City of Tucker

Land Use Petition: RZ-22-0001

Date of Staff Recommendation Preparation: April 7, 2022

PROJECT LOCATION:	3207, 3217, 3227, 3259 Lawrenceville Highway and 3563 Bishop Drive
APPLICATION NUMBER	RZ-22-0001
DISTRICT/LANDLOT(S):	Land District 18, Land Lots 165 & 166
ACREAGE:	8.72 acres
EXISTING ZONING	R-75 (Residential Medium Lot - 75)
EXISTING LAND USE	Single-family homes
FUTURE LAND USE MAP DESIGNATION:	Suburban
OVERLAY DISTRICT:	N/A
APPLICANT:	Embry Development Company
OWNER:	St. Sophia, LLC., St. Jolie, LLC., Robert McDonald, Estate of M. Frances McDonald (Donald McDonald)
PROPOSED DEVELOPMENT:	Rezoning from R-75 to RSM to allow for the development of 52 townhomes.
STAFF RECOMMENDATION:	APPROVAL WITH CONDITIONS of RZ-22-0001

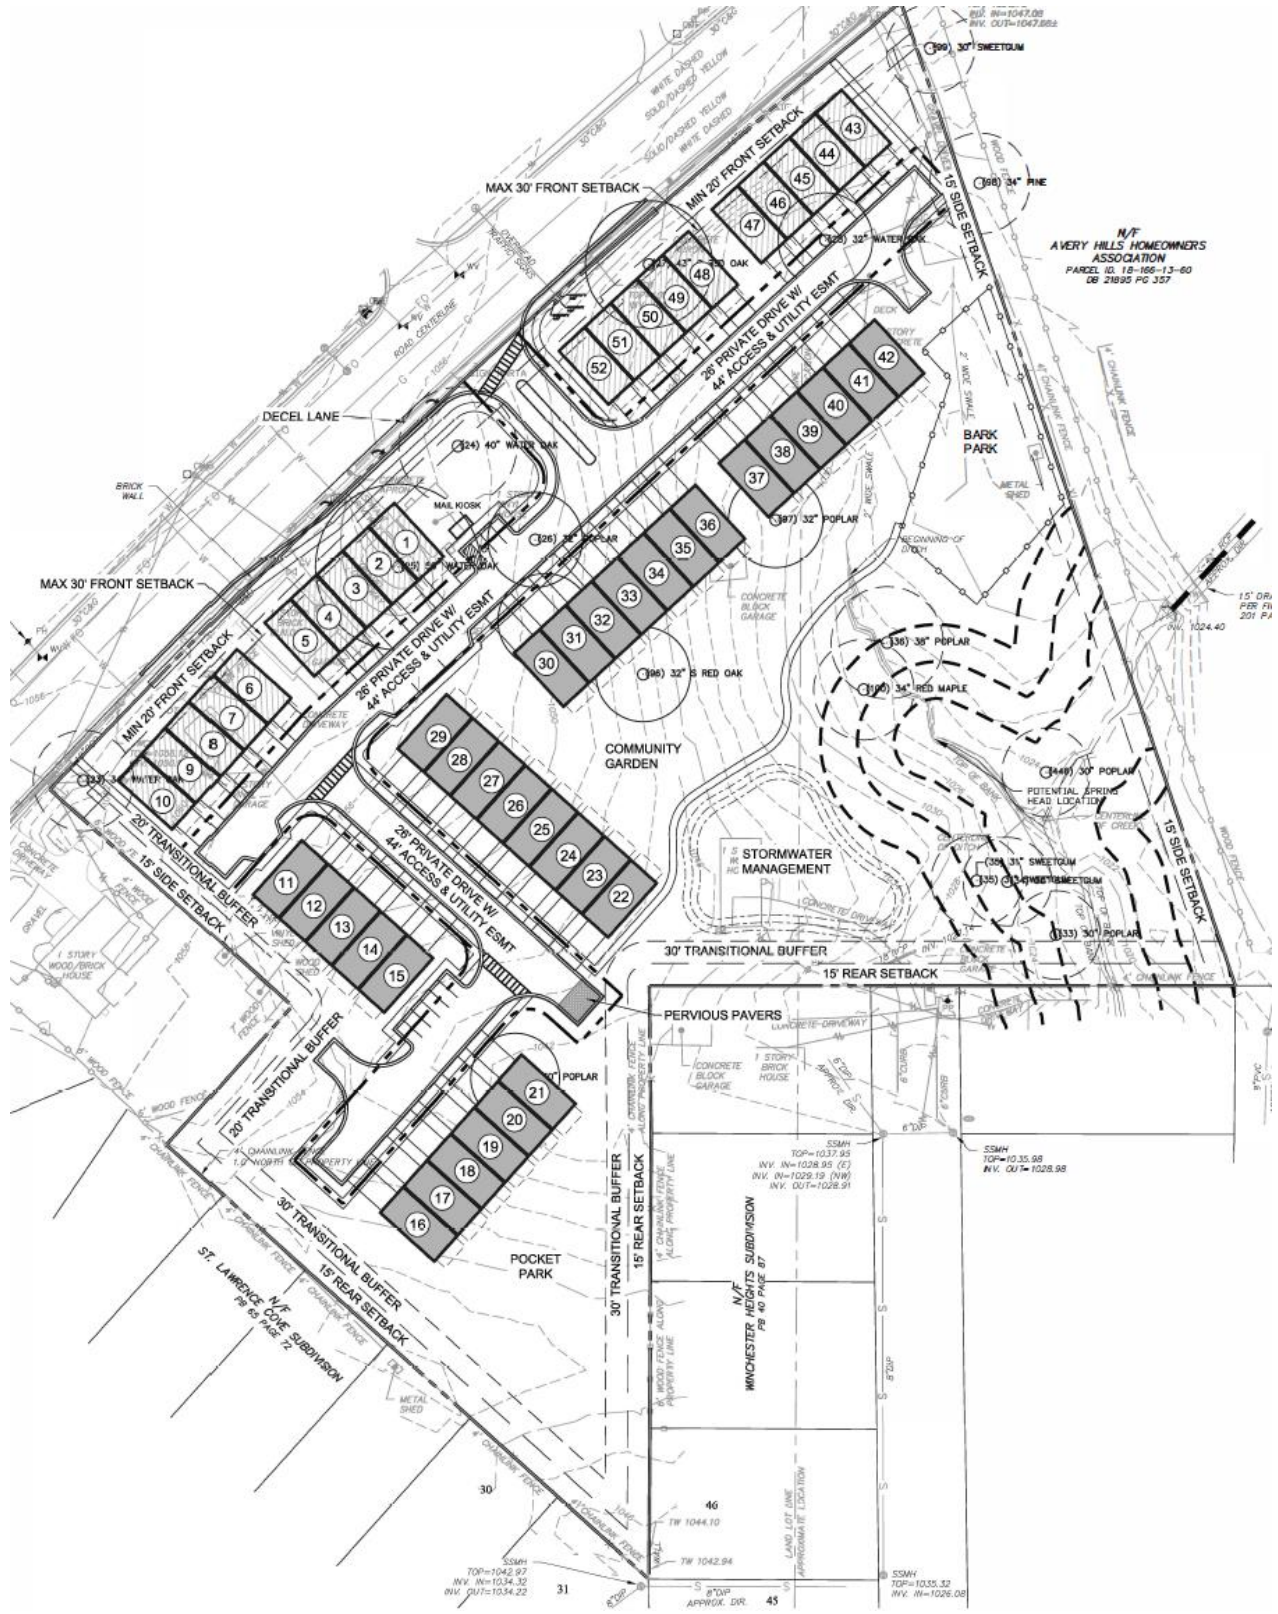
The maximum height allowed within the RSM zoning district is 45' or 3 stories, whichever is less. While exact heights of the proposed townhomes were not submitted with the application, the applicant has stated the townhomes will comply with the City's requirements. From submitted elevations, the proposed townhomes appear to be 3 stories and will be constructed of a mixture of brick, board and batten, and shake, in a neutral palate.

Access is shown via one full-access drive from Lawrenceville Highway, that would line up with Terri Lynn Court when constructed. There are 13 guest parking spaces throughout the site, with three adjacent to the proposed mail kiosk. DeKalb Fire will require the townhome units to be sprinkled since only one vehicle access point is provided.

The site plan also shows a transitional buffer along the eastern, western, and southern sides of the development. Transitional buffers in residential neighborhoods are intended to diminish the potential negative impacts of higher intensity residential development on adjacent single-family residential land uses. The applicant has proposed a 30' transitional buffer along the southern and a majority of the western property lines, which exceeds the City's 20' transitional buffer requirement for the RSM zoning district.

While only 20% of the site is required to be reserved for open space, the submitted site plan shows several open space areas, totaling 4.5 acres (52% of the site), including a pocket park, in the southern portion of the property, adjacent to the St. Lawrence Cove subdivision and residential dwellings along Bishop Drive; a community garden, central to the development; and a bark park, along the eastern property line, north of the stream on the property. The submitted site plan shows full compliance with the dimensional requirements of the RSM zoning district.

The applicant could do more with regards to the goal of managing massing, by taking into consideration the smaller footprints and total square footage of existing housing stock. This could be achieved with a mix of product types, specifically within the southwest corner of the development where it abuts both St. Lawrence Cove and Bishop Drive residences.

- Based on the proposed site plan, because there are more than 30 units on a single access road, there would need to be a second access point for fire apparatus access.
- Alternatively, each unit shall be equipped with an approved fire sprinkler system per International Fire Code Appendix D Section D107.

- LDP will be required, including landscape plans, tree density calculations, and a hydrology report.
- Detention will need to be vetted as it is unclear if the proposed underground detention will be tied to the existing system.
- Compliance with private roads meeting DeKalb Fire standards will be required.

1. Use of the subject property shall be limited to up to a 52-unit townhome development.
2. The property shall be developed in general conformance with the site plan submitted on March 28, 2022 to the Planning and Zoning Department, with revisions to meet these conditions.

3. The twenty units along Lawrenceville Highway shall be rear-loaded and designed so that their front façade/entry faces Lawrenceville Highway.
4. Dwellings shall have a minimum heated floor area of 1,500-square feet.

9. The side elevations of units 1, 5, 6, 10, 43, 47, 48, and 52 shall be clad in the primary building material of the front façades and designed with windows and other architectural features in order to provide a consistent design appearance along Lawrenceville Highway.
